APPLICATION NO.	FILING DATE	FIRST NAMED INVENTOR	ATTORNEY DOCKET NO.	CONFIRMATION NO.
10/810,752	03/26/2004	William Gross	IDEALAB.043A	9078
20995 7590 07/24/2007 KNOBBE MARTENS OLSON & BEAR LLP 2040 MAIN STREET FOURTEENTH FLOOR IRVINE, CA 92614			EXAMINER PAINTER, BRANON C	
			ART UNIT 3609	PAPER NUMBER
			NOTIFICATION DATE 07/24/2007	DELIVERY MODE ELECTRONIC

Office Action Summary	Application No.	Applicant(s)	
	10/810,752	GROSS, WILLIAM	
	Examiner	Art Unit	
	Branon C. Painter	3609

DETAILED ACTION

FIG. 1

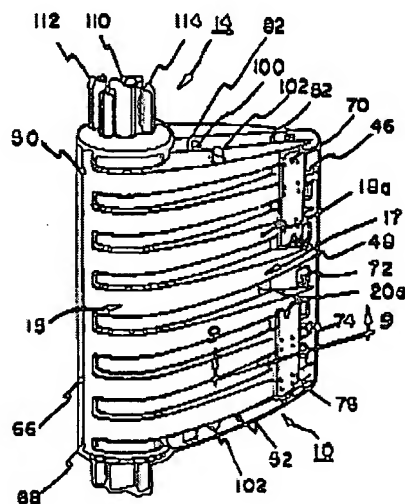
- a. Hale discloses a fairing apparatus with the following structure: a hollow elongate fairing sleeve...rotatably secured to a support member, the hollow elongate sleeve having a shape configured to reduce aerodynamic drag force acting on the support member ("fairing" 10, Figs. 1 and 4) [claim 1]; wherein the fairing is secured to the support by at least one bearing joint ("collar" 104 with "bearing pads" 118, Figs. 10 and 12) [claim 2]; wherein the fairing has a first and second end with accompanying bearing joints at each end ("bearing pads" 118, Fig. 12) [claim 3]; and wherein the fairing has a lateral support structure inside the fairing sleeve comprising a plurality of bearings ("collar" 104 with "bearing pads" 118, Fig. 12) [claim 4].

- a. Hale discloses a fairing apparatus with the following structure: an elongate fairing sleeve having a first axis, covering a portion of a support member, configured to rotate around a support member on the first axis, and shaped to reduce aerodynamic drag force acting on the support member ("fairing" 10, Figs. 1 and 4) [claim 6]; wherein the covered portion of the vertical support has a greater drag coefficient than the fairing ("fairing" 10, Fig. 1) [claim 8]; wherein the fairing has upper and lower ends, with the lower end displaced from the foundation by a first height ("fairing" 10, Fig. 1) [claim 10]; and wherein there is included a safety shield closer to the foundation than the fairing ("collar" 104 at the bottom of "fairing" 10, Figs. 10 and 12) [claim 11].

- a. Hale discloses a fairing apparatus with the following structure: a hollow elongate fairing sleeve...rotatably secured to a support member, the hollow elongate sleeve having a shape configured to reduce aerodynamic drag force acting on the support member ("fairing" 10, Figs. 1 and 4) [claim 1]; and an elongate fairing sleeve having a first axis, covering a portion of a support member, configured to rotate around a support member on the first axis, and shaped to reduce aerodynamic drag force acting on the support member ("fairing" 10, Figs. 1 and 4) [claim 6].

FIG. 10

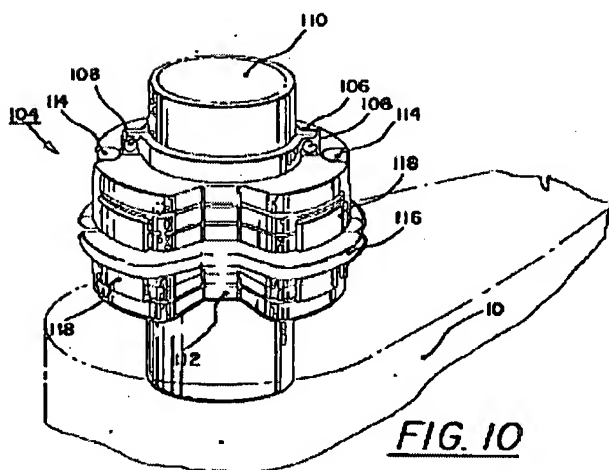
- a. Hale discloses a fairing apparatus with the following structure: the structure of claim 6 as detailed above; wherein the fairing is rotatably secured to the support by at least one bearing joint ("collar" 104 with "bearing pads" 118, Figs. 10 and 12) [claim 15]; wherein the fairing has a first and second end with accompanying bearing joints at each end ("bearing pads" 118, Fig. 12) [claim 16]; and wherein the fairing has a lateral support structure inside the fairing sleeve comprising a plurality of bearings ("collar" 104 with "bearing pads" 118, Fig. 12) [claim 17].

Reproduced from U.S. Patent No. 5,398,478

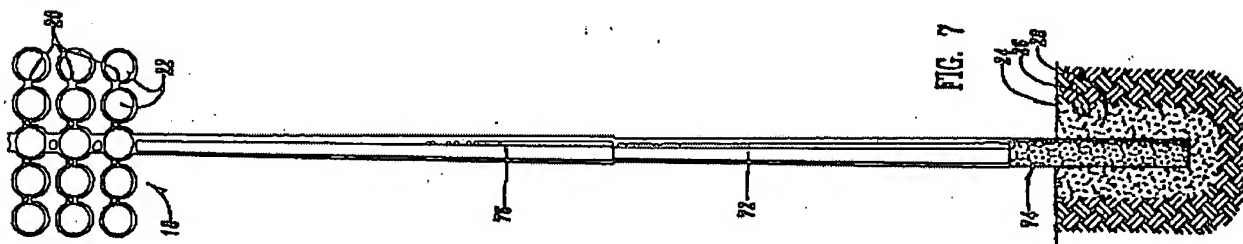
- d. Gordin et al. discloses a vertical support member anchored in a foundation and subjected to an aerodynamic drag force ("pole sections" 72 and 76 with "base" 74 and "foundation" 28, Fig. 7) [claim 1]. Attaching the fairing of Hale to a vertical support member like the one taught by Gordin et al. reduces the wind drag on the support member, allowing the member to withstand more significant drag forces due to wind velocities.

- c. Gordin et al. discloses: a vertical support member anchored in a foundation and subjected to an aerodynamic drag force ("pole section" 72 with "base" 74 and "foundation" 28, Fig. 7) [claim 1]; wherein the support member has a tapered end and is received by a member with a cupped support receptacle ("pole section" 72 received by "pole section" 76, Fig. 7). Attaching the fairing of Hale to a vertical support member like the one taught by Gordin et al. reduces the wind drag on the support member, allowing the member to withstand more significant drag forces due to wind velocities. Furthermore, modifying the fairing of Hale to include a cupped receiving structure as taught

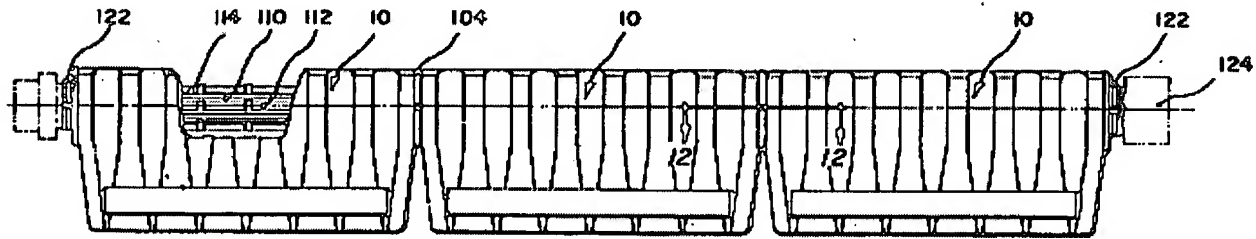
- a. Hale discloses a fairing sleeve covering at least a portion of a support member and configured to rotate around the support member ("fairing" 10 with "collar" 104 and "bearing pads" 118, Figs. 1, 4, 10, and 12), and further discloses a plurality of fairings along the length of a support member ("fairings" 10, Fig. 11) [claim 25].
